# SM-PMA delay constraints (comment # 451)

IEEE 802.3dj January 2025 interim meeting

# PMA delay constraints for 200G/lane (802.3dj D1.3)

#### From Table 176-7 : Delay constraints in Draft 1.3

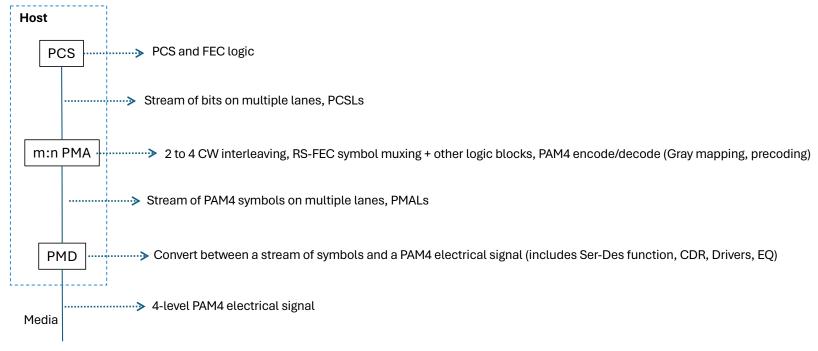
- Table contains numbers for 800GE ==> copied from 802.3df
  - 32:4 PMA delay allocation is same as 32:8 PMA from 802.3df
  - 4:4 PMA delay allocation is same as 8:8 PMA from 802.3df
  - Delay of the 4:4 PMA is 2x of 32:4 PMA
- Other PMA delays TBD
- 1.6TbE 16:16 PMA not present in Table 176-7

### m:n SM-PMAs: Proposed delay constraints

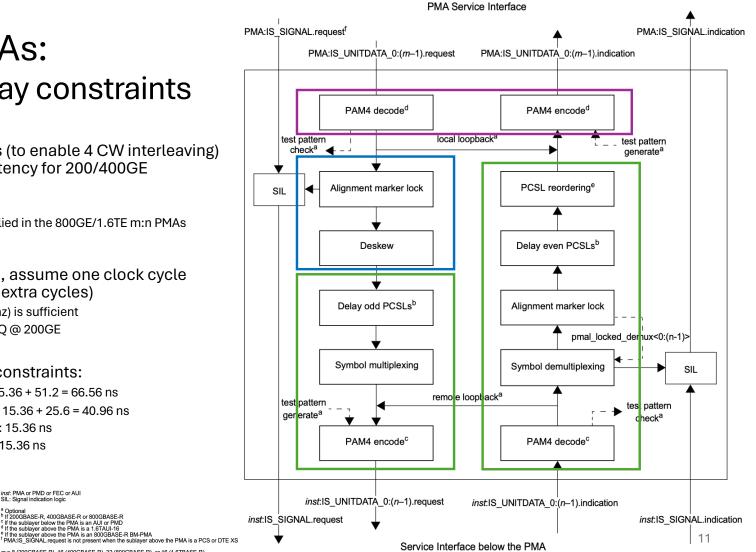
- Delay of alternating lanes (to enable 4 CW interleaving) ٠ results in a fixed 2-CW latency for 200/400GE
  - 51.2ns for 200GE
  - 25.6ns for 400GE ٠
  - The 2-CW delay is not applied in the 800GE/1.6TE m:n PMAs ٠
- For the other logic blocks, assume one clock cycle delay per block (plus few extra cycles)
  - A budget of ~ 15 ns (at 1Ghz) is sufficient
  - Round up to 15.36ns = 6 PQ @ 200GE
- Propose following delay constraints:
  - 200GE 8:1 and 1:8 PMA : 15.36 + 51.2 = 66.56 ns
  - 400GE 16:2 and 2:16 PMA: 15.36 + 25.6 = 40.96 ns
  - 800GE 32:4 and 4:32 PMA : 15.36 ns ٠
  - 1.6TE 16:8 and 8:16 PMA : 15.36 ns ٠

### n:n SM-PMAs: Proposed delay constraints

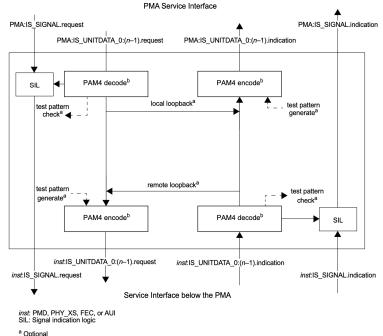
- n:n PMA has back-to-back PAM4 encode/decode functions
  - Other functions typically associated with "Serdes" are in the C2M/C2C component or in the PMD
- Assume one clock cycle for each of the PAM4 encode/decode logic block plus a few additional cycles (6 cycles) between blocks per direction (4 + 6 + 6 = 16 total)
  - Assume budget of ~16ns delay round-trip (1 Ghz clock)
  - Round down to 15.36 ns = 6 PQ @ 200GE
- Propose using 15.36 ns for n:n SM-PMAs
